RE: Comments of the Minnesota Department of Commerce
Docket No. E999/M-25-99

In the Matter of the 2025 Biennial Transmission Projects Report.

Comments of the Minnesota Department of Commerce

Docket No. E999/M-25-99

Figure 1: INL Payback Period Chart⁶

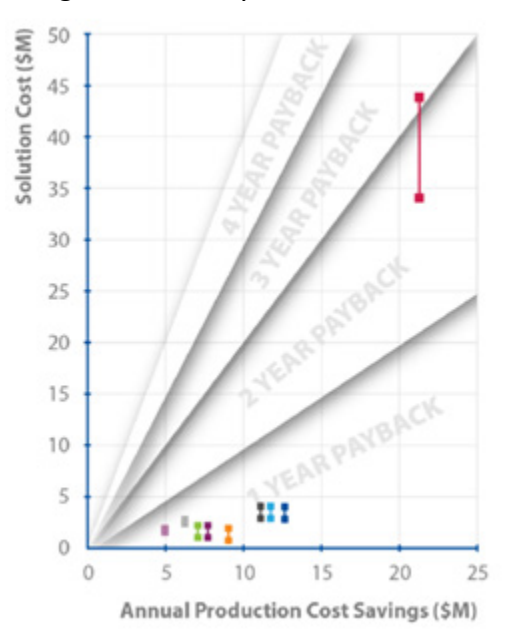
In this instance the analysis comparing Solution Cost to Annual Production Cost Savings, as shown in Figure 1, appears to be flawed. The proposed analysis would compare annual revenues actually received by ratepayers (the flow of production cost savings) to a cost that is not actually paid by ratepayers (the solution’s capital cost, which is a stock or onetime payment). The flaw stems from the lack of relation between the two amounts being compared; while production cost savings are realized by ratepayers, the solution’s cost would not be paid by ratepayers (or received by shareholders) in one installment, as assumed in Figure 1. Instead, ratepayers would pay the cost of the project over a number of years, the duration of which reflects the life of the project. The actual cost paid by ratepayers could vary widely depending on the expected life of the projects, rate of return, and several other factors.

At this time, it is not clear to the Department how to calculate a technically valid payback. Further development by the utilities is warranted. However, one analysis would be to calculate the cost paid by ratepayers each year for the project as documented in Table 2 above. Then, the present value the stream of annual costs would be calculated using the appropriate discount rate. The analysis would calculate the ratepayer benefits each year as documented in Table 1 above. The present value of the stream of benefits using the same discount rate would be calculated. Then the two present value

numbers, one for costs and one for benefits, can be compared to arrive at a valid comparison—a benefit/cost ratio (BCR).
